Access Compliance Report

Public Rights-of-Way

(Pedestrian Signals)

Intersection ID: N/A	Main Street:	Cross Street: N/A	Location: N/A
ADA ID: FD000FB7E199	Signal Type: One Push Button-Non APS	Overall Compliance: No	Severity Score: BTN 1: N/A BTN 2: N/A No BTN: N/A
Codes/Mitigation Info/Possible Solution		Field Measurements/Component Compliance

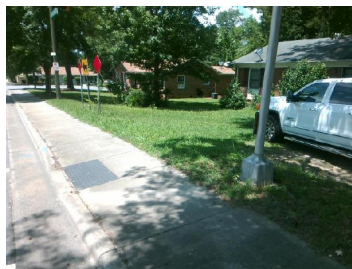
Surveyor Notes: TEXT HT1/2

PROW/ADA: R410.6, TMUTCD 4e.08, R404.2, R404.3, R404.7.3

Possible Solutions: Replace Signal Push Button With APS Button on New Post. Remove & Replace Sign.
